HARRIS

SERVICE BULLETIN

MW-1/MW-1A

AM-120-LAP
ECN 23812

RF Heatsink Assembly

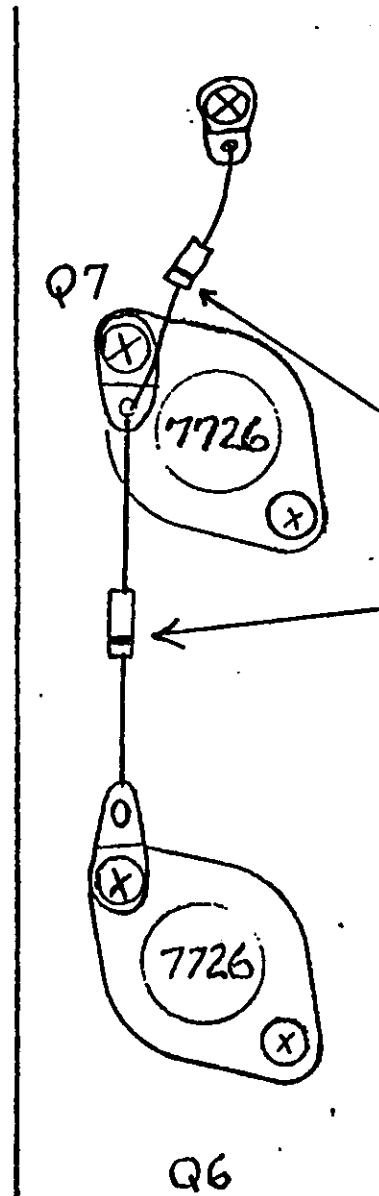
PROBLEMS ENCOUNTERED: Ringing of class 'D' waveform, random and premature loss of Q6 and Q7 in A-1 through A-13 PA module assemblies (992-4201-001), assymetrical PA voltage dip while tuning the transmitter.

The major supplier of these 2N6340 transistors (Motorola) has changed the doping mixture used to manufacture the collector-emitter junction's structure. Thus, the newly created junction characteristics may cause the operational duty cycle to be unstable.

LCR-1 and LCR-2 (25 nanosecond reverse recovery time diodes) have been added across the emitter collector of Q6 and Q7; A-1 through A-13.

Place solder lugs under transistor mounting screws as shown in attached drawing. Cut both LCR-1 and LCR-2 diode leads approximately the same length. Dress leads carefully, making sure they don't come in direct contact with other components. Be sure to heat sink carefully the diode leads when soldering.

CR1, CR2
Harris Part # 384 0678 000
TRW, Model No. DSR 3200

CR1, CR2 have been
added as in schemat
diagram
